**HOMES NSW
46 CHESTER AVENUE
MAROUBRA NSW 2035**

**BUILDING CODE OF AUSTRALIA 2022
STAGE C DESIGN DEVELOPMENT REVIEW
MARCH 2024**

Report prepared for	Homes NSW Locked Bag 4009, Ashfield NSW 1800 Attention: Patrick Koe
Report prepared by	Metro Building Consultancy Suite 15.14, 60 Station Street Parramatta 2150 Consultant: Sean Moore
Report reference	23192R03
Job number	23192
Date	12 th March 2024

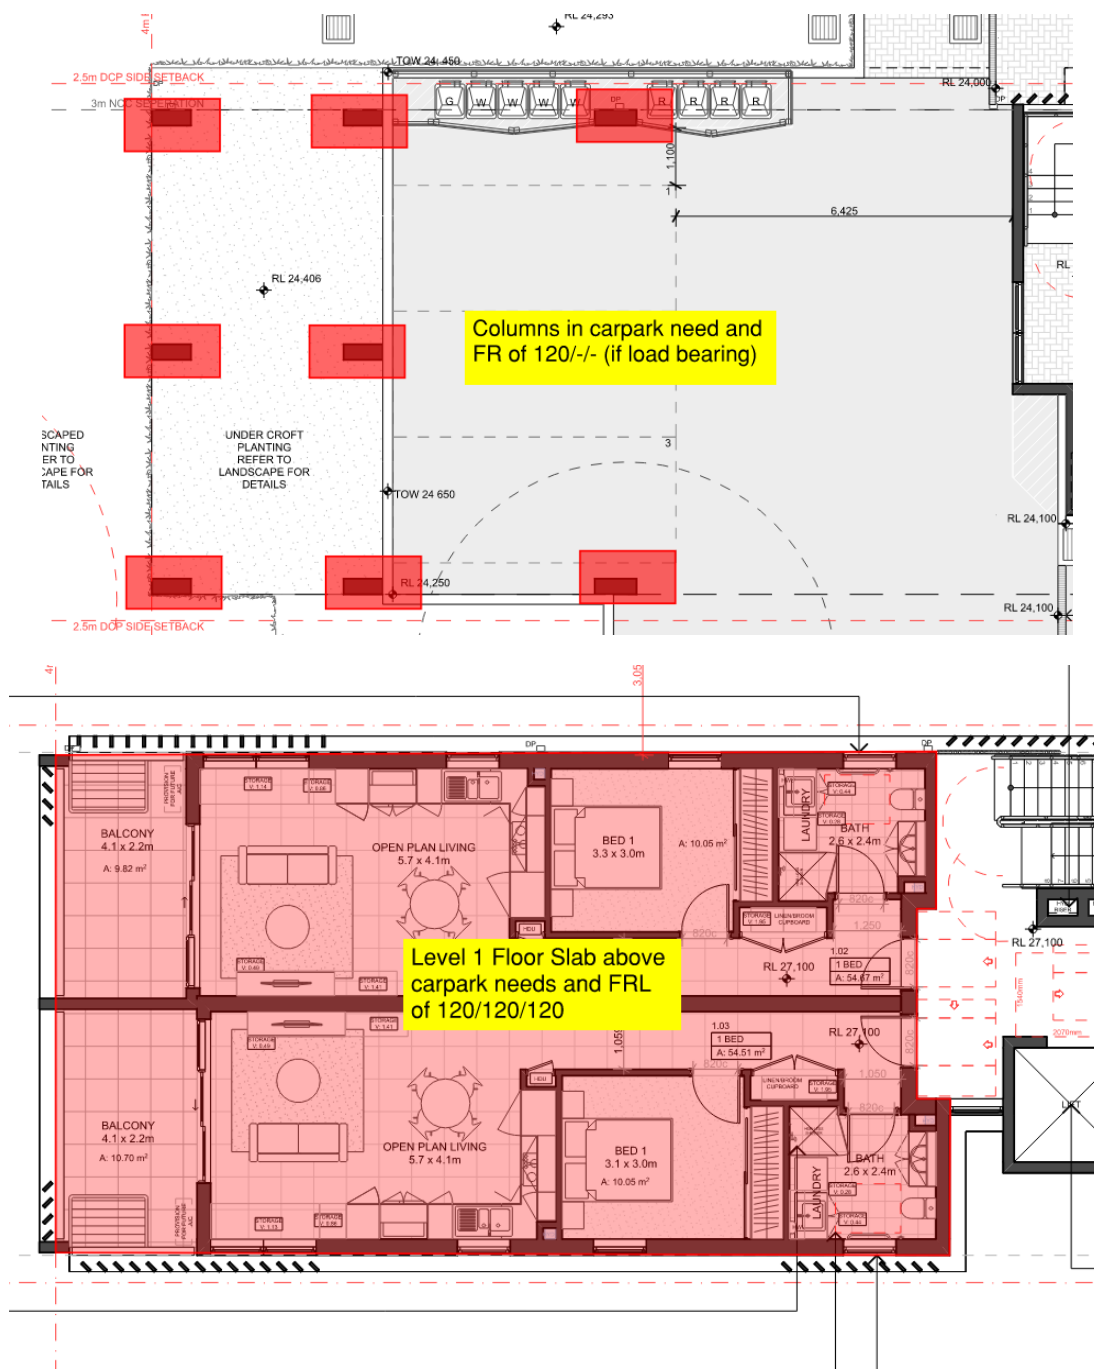
The undercroft carpark on ground floor contributes to the floor area even though there is no bounding construction.

The undercroft carpark on the ground floor is more than 10% of the floor area as such the external elements supporting the carpark requires an FRL or 2 hours rather than 90 minutes needed for the residential units.

Under BCA Clause C3D10 the floor between the adjoining parts must have an FRL not less than the storey below. As the storey below level 1 is carpark then the residential floor slab is required to achieve the FRL of the storey below which is 120/120/120.

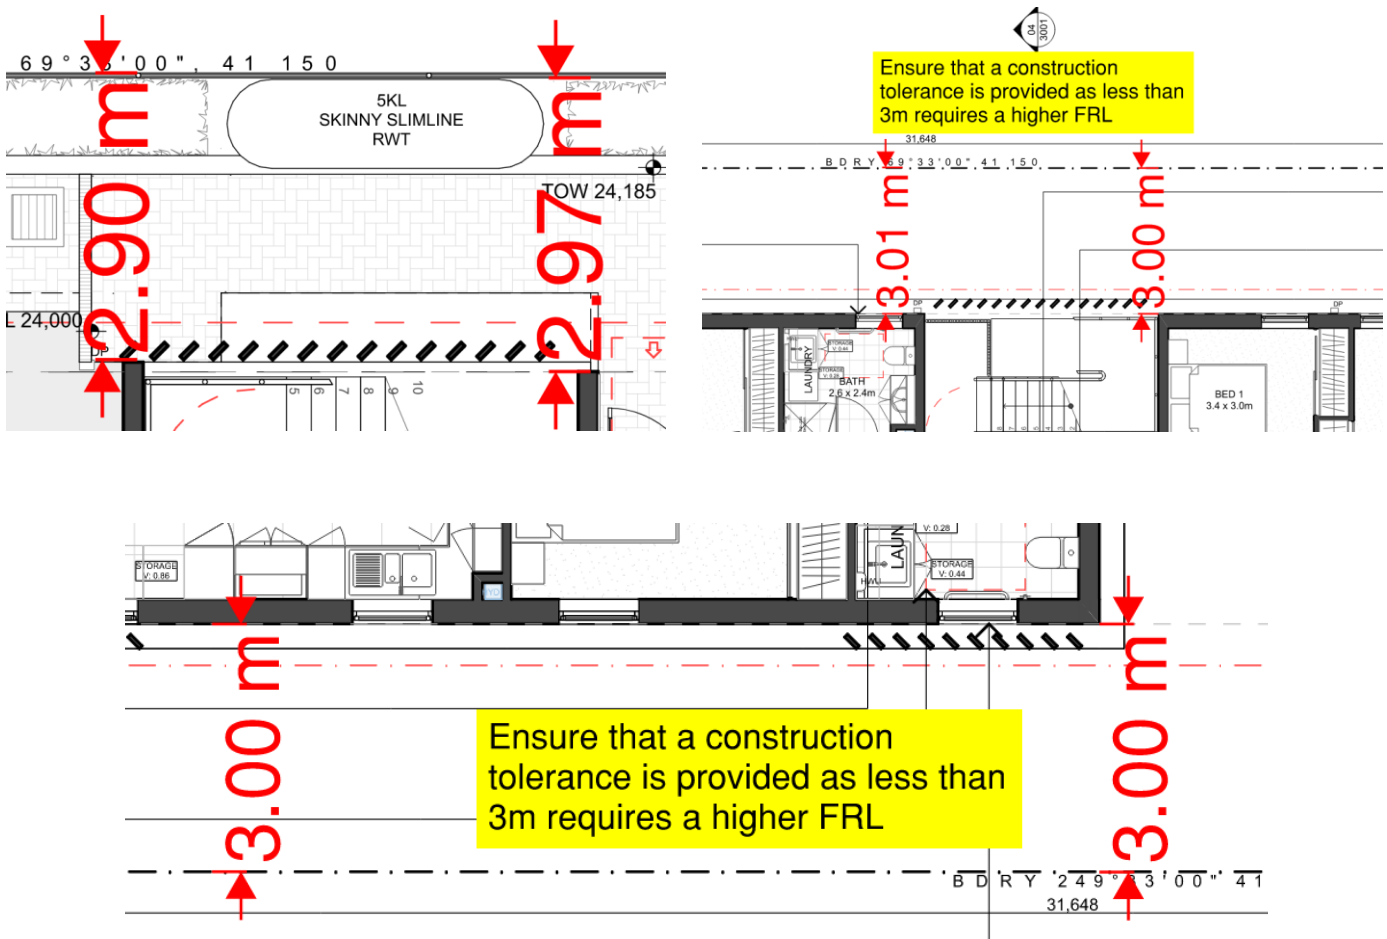
Parts of the northern wall on ground floor that are within 3m from the boundary triggers the wall to have a higher FRL than the other parts of the wall that are 3m away from the boundary.

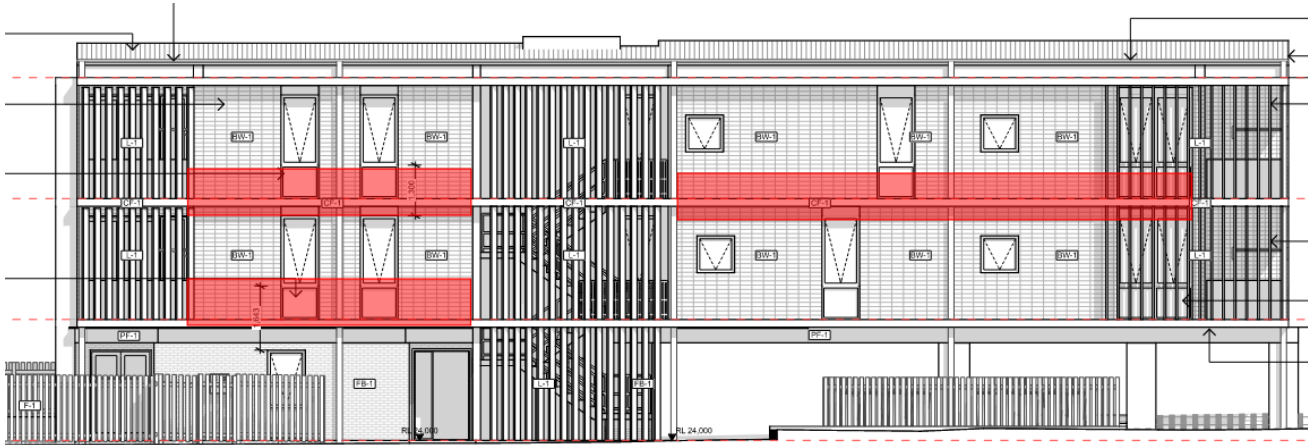
Spandrel protection is needed throughout regardless of window location due to the external wall not having an FRL of 60/60/60. Please confirm FRLs of external wall.

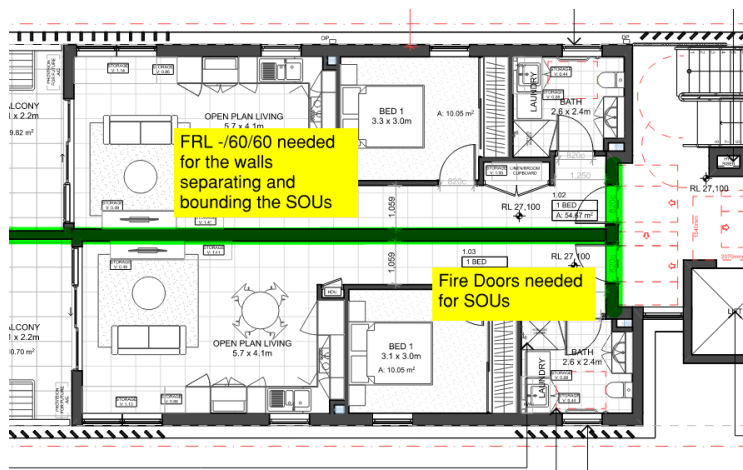
Even if the doors from the apartments do not open to a public corridor (if the walkways outside the apartments are not fully enclosed) the doors do open to a 'public lobby (no BCA definition) or the like' and the doors to the apartments are required to be protected with 1 hour self closing fire doors.

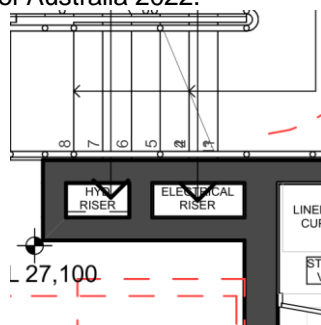
This applies to any proposed garbage chute and electrical and communication services cupboards on each floor if they are housed in a shaft.

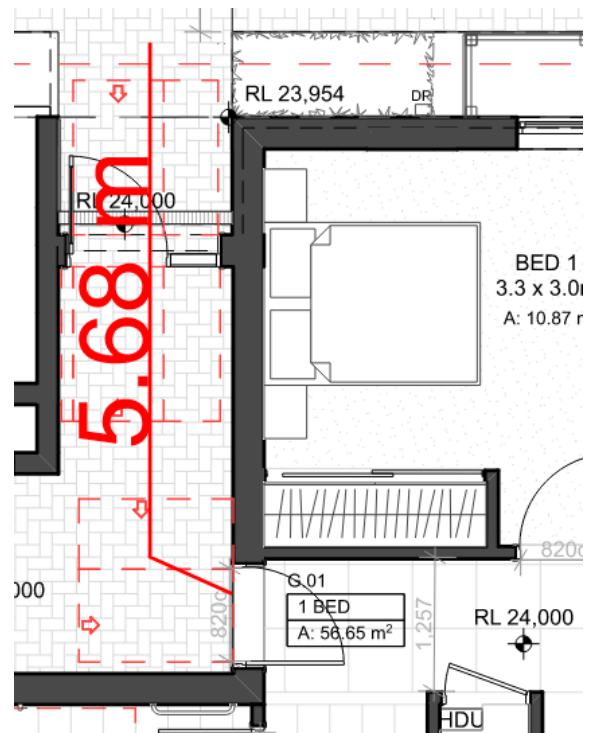
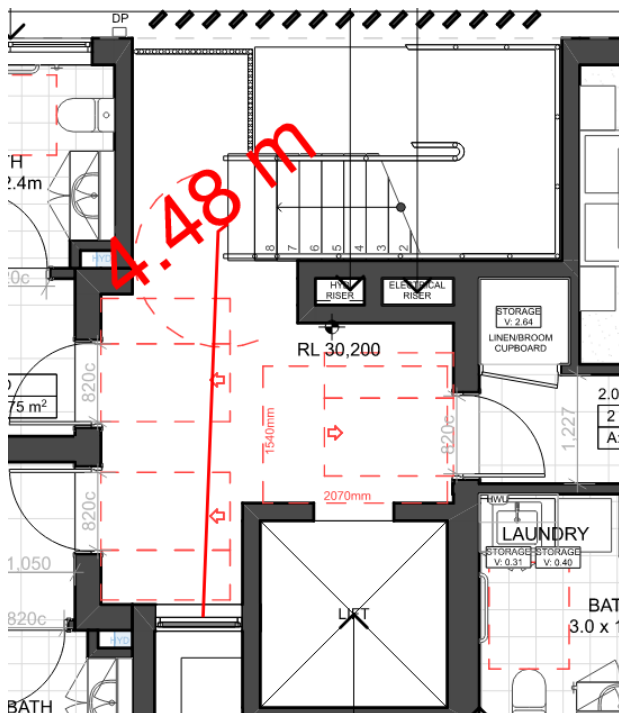
Travel distances comply.

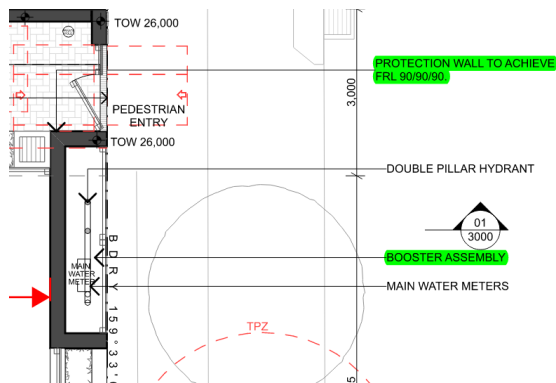
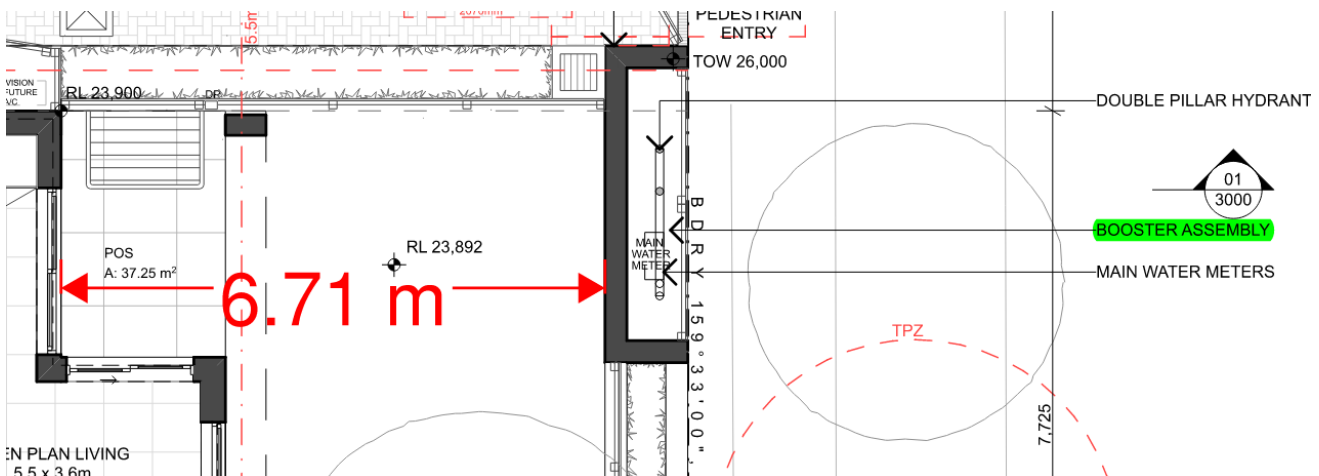
All points of the floor to be within 40m of an internal hydrant.

Internal fire hydrants shall be located within 4m from the stairs.

Please provide details to confirm compliance has been achieved.

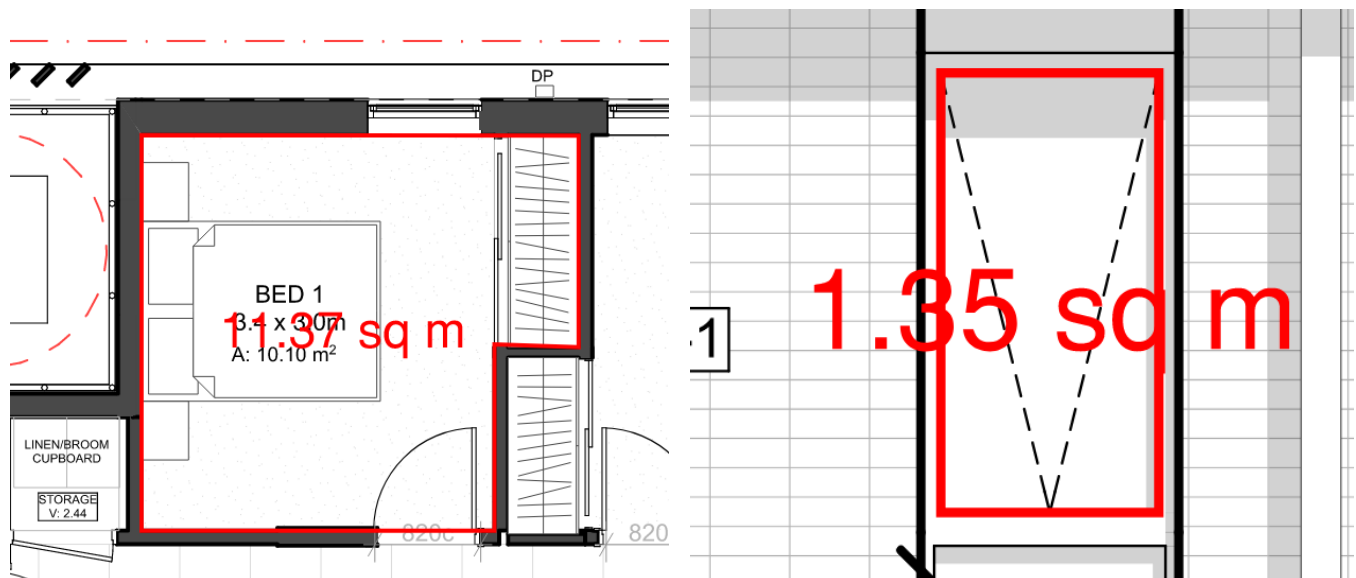
Architect to provide window details providing details of the openable area for natural light for review prior to the issue of the Crown Works Certificate. Please note that if design changes are required to meet BCA compliance after the DA has been approved then a s4.55 modification to the DA approved drawings may be required.
